A. Project Information				
Building number, street name		Postal code	Plan number/ other description	Unit no. 42-02 'A'
Municipality VAUGHAN				Lot/con. 25

PROJECT/LOCATION
KLEINBURG GLEN-PH2
VAUGHAN, ON

DRAWING
SITE PLAN

SITE PLAN REVIEW

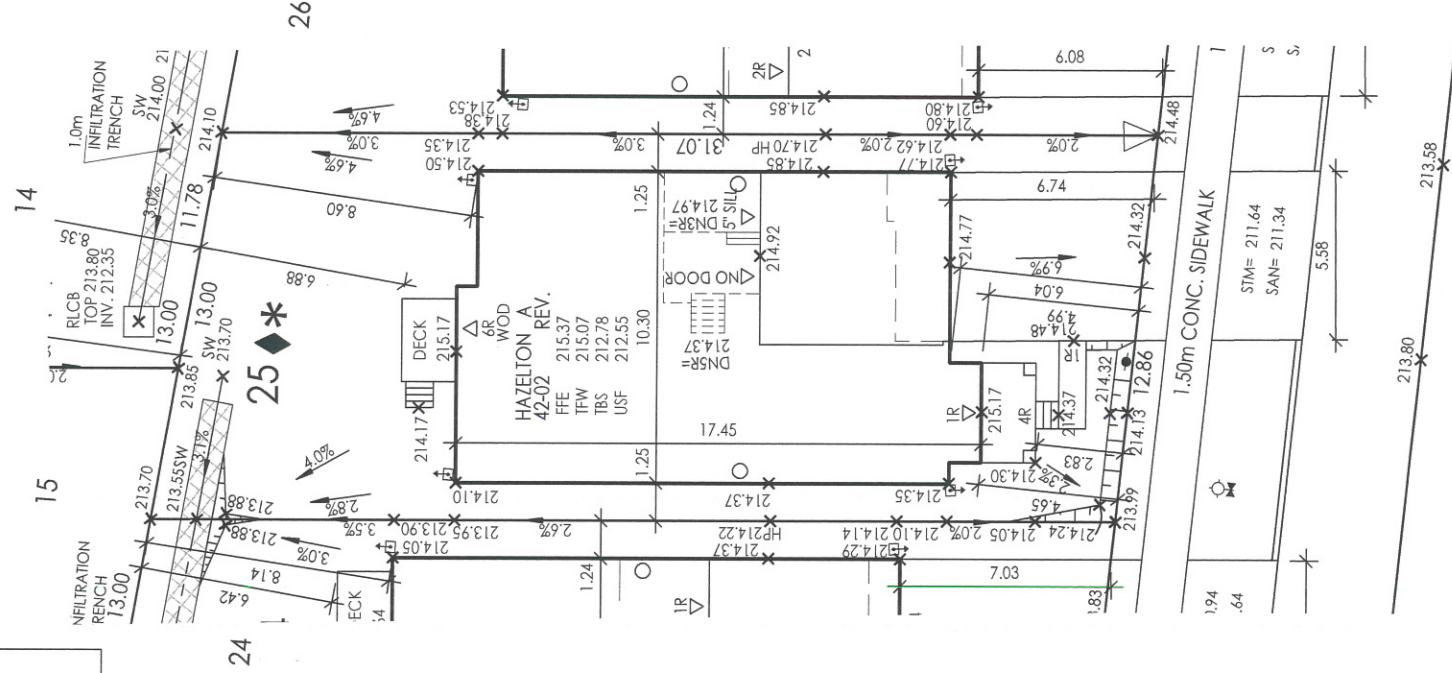
THE PROPOSED LOT GRADING AND DRAINAGE IS APPROVED AS BEING IN CONFORMITY WITH THE OVERALL APPROVED GRADING PLANS FOR THE SUBDIVISION.

NO COMMENT
COMMENTS AS NOTED
☒ REVIEWED BY SK
☐ DATE Mar. 13, 2017
